SERVICE BULLETIN

Service Bulletin No.: D42L-34-03 Rev 2

Title: ADF System Improvements

Revision 2 of this SB changes the orientation of the EMI Filter.

Figure 2

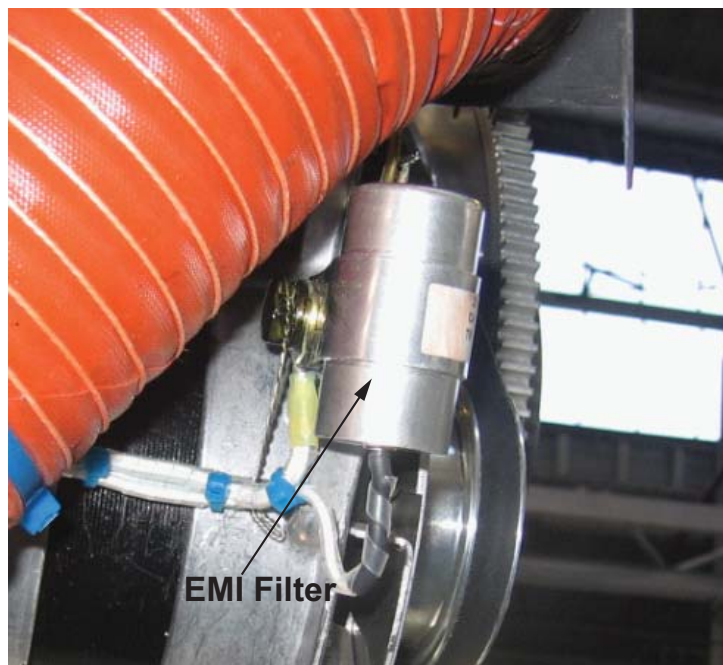
- 10.1.5 Apply spiral wrap (P/N 1N) to ADF filter pigtail.
- 10.1.6 Install the EMI filter (P/N A-9756) onto the alternator flange as shown in Figure 2.
